# PRODUCT CHANGE | ROUND Open Bracket | Universal

DISCONTINUED PRODUCT	REPLACEMENT PRODUCT	CHANGES MADE	
			YES	NO
DESCRIPTION.	Open Blind Brackets - Steel	Open Blind External Brackets	<input checked="" type="checkbox"/>	<input type="checkbox"/>
CODE.	RE01-3001-012067 – Stainless RE01-3002-xxx067 – Powder coat	RE01-3020-xxx000 – Powder coat RE01-3021-012000 – Stainless	<input checked="" type="checkbox"/>	<input type="checkbox"/>
PACK SIZE.	2   20 Sets	2   20 Sets	<input type="checkbox"/>	<input checked="" type="checkbox"/>
PRICE.	<i>As per current region price list. No changes.</i>		<input type="checkbox"/>	<input checked="" type="checkbox"/>
COLOUR / FINISH.			<input type="checkbox"/>	<input checked="" type="checkbox"/>
IMAGE.			<input type="checkbox"/>	<input checked="" type="checkbox"/>
ITEMS NO LONGER REQUIRED.	- RE01-3003-xxx000; Open Bracket Covers + Screws - RE01-0403-013000; External Booster Spacer - RE01-3012-033000; Zipscreen Open Bracket Template		<input type="checkbox"/>	<input type="checkbox"/>

## IMPROVEMENTS / CHANGES

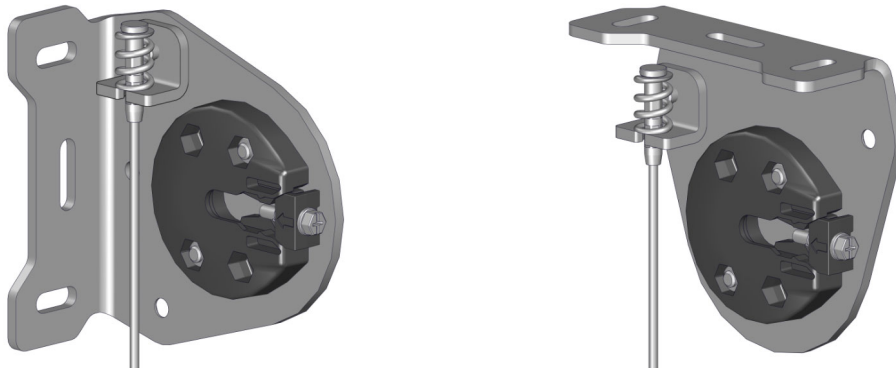
- Compatible with all wire guide terminals for all bracket orientations.
  - Including top fix with Zamak motor adaptor.
- No spacer adaptor required for Spring controlled wire guide.
  - Subtract 8mm from existing tube deduction.
- Not compatible with zipscreen open bracket template.
- No covers available.
- Monument (057) stocked as standard offering.
